COUNCIL MEETING

CONCEPT PLAN

Project Summary

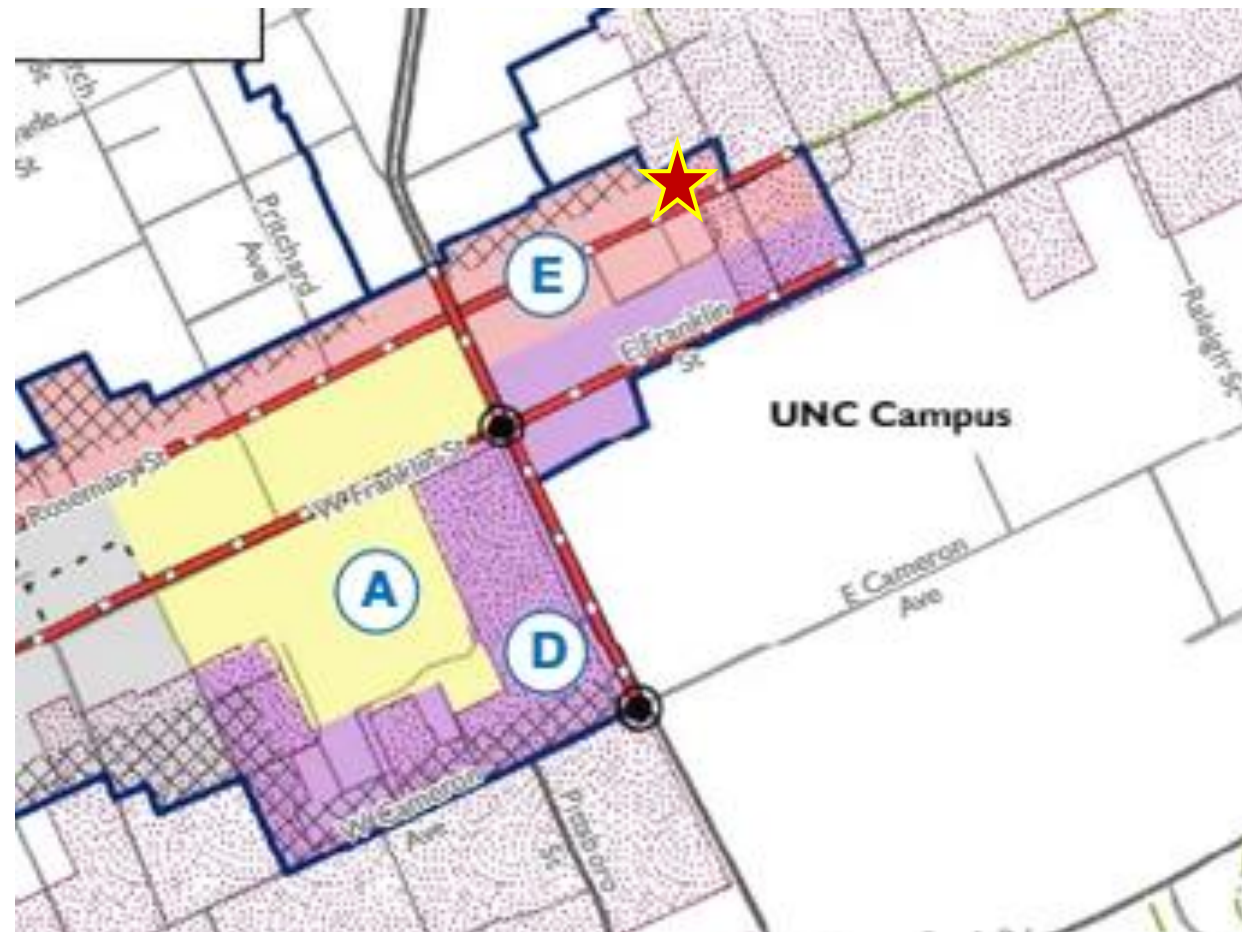
- Height should provide transition, avoid canyon effect, include quality architecture
- Possibility of integrated development with adjacent property
- Have step backs or articulation on multiple sides of building
- Address exposed parking level
- Consider impacts of traffic and service vehicles
- Iterative design review

- Consider affordable units comparable in size
- Consider interspersing affordable units

- Provide space along street for shade trees, seating, pedestrian features
- Design exposed portions of parking level to integrate with building architecture
- Roof of parking level as pedestrian amenity or green roof
- Consider flipping retail to east side, aligned with future Town green across the street
- Height should be in between lab building and lower-scale residential to the north
- Articulation measures for north side of building
